Document Review Comment Sheet

PROJECT TITLE: THAI BINH2 THERMAL POWER PLANT 2 x 600MW

DRAWING TITLE: SECTIONAL DRAWING FOR MAIN BFP

DRAWING NO. TB2-SDC.VP103-00LAC-M-M1B-DSE-0001

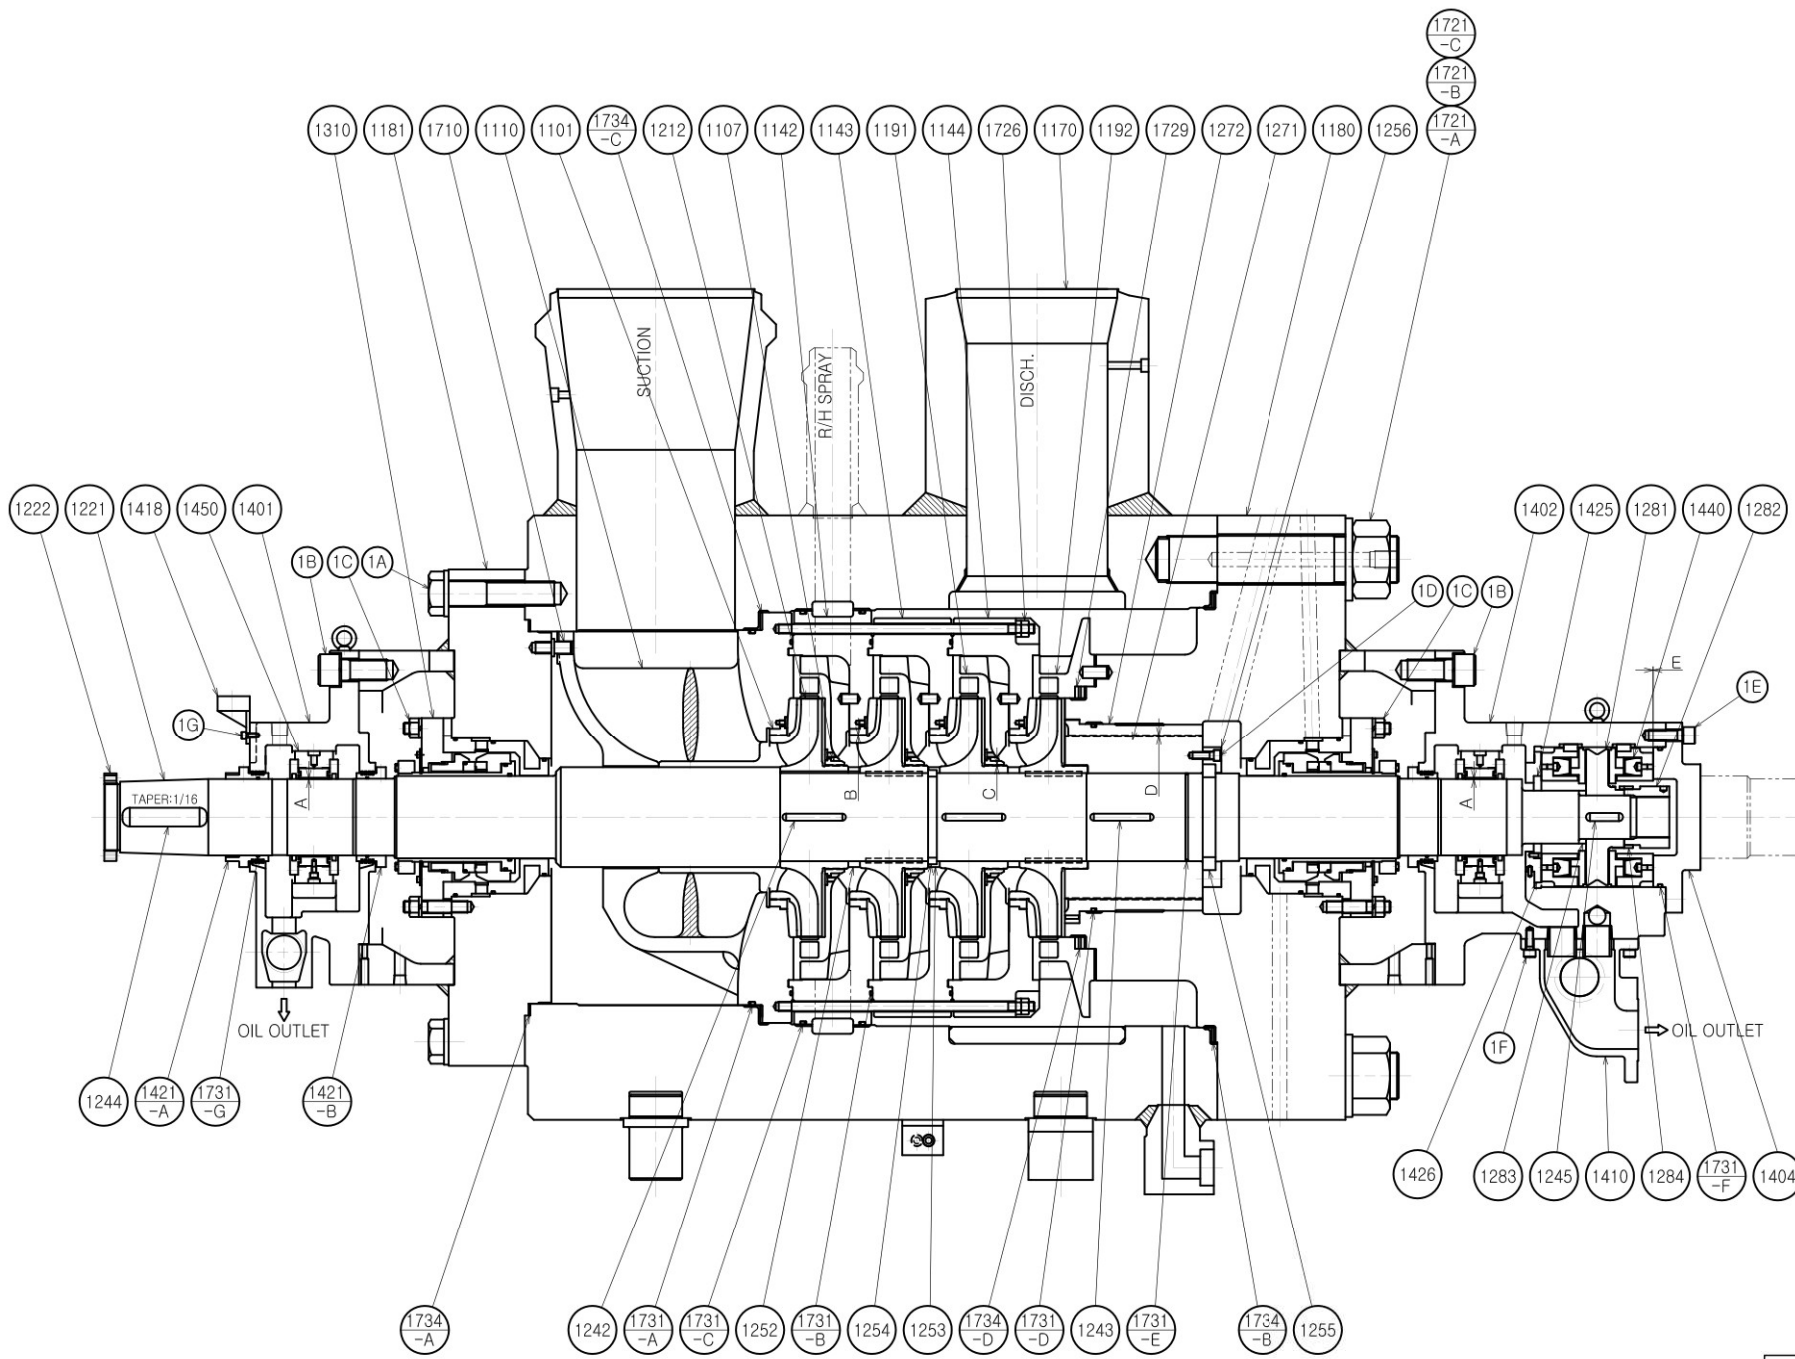
No.	Document No.	Rev	Title	Purpose	Approval Status																							
1	TB2-SDC.VP103-00LAC-M-M1B-DSE-0001	0	SECTIONAL DRAWING FOR MAIN BFP																									
No.	Daelim's Comments		Vendor's Response																									
1	Pls, check C value.(TYP.) <table><tr><td colspan="2">NOZZLE RATING</td></tr><tr><td>SUCTION</td><td>DN350 SCH.40, BW</td></tr><tr><td>DISCHARGE</td><td>DN350 (I.D=273) BW</td></tr><tr><td>R/H SPRAY</td><td>DN65 SCH.80, BW</td></tr></table><table><tr><td colspan="3">DOCUMENT SUBMISSION STATUS IF</td></tr><tr><td colspan="3">NOTE</td></tr><tr><td></td><td></td><td></td></tr><tr><td></td><td></td><td></td></tr><tr><td></td><td></td><td></td></tr></table>		NOZZLE RATING		SUCTION	DN350 SCH.40, BW	DISCHARGE	DN350 (I.D=273) BW	R/H SPRAY	DN65 SCH.80, BW	DOCUMENT SUBMISSION STATUS IF			NOTE												The C value is ϕ 282.3 mm.		
NOZZLE RATING
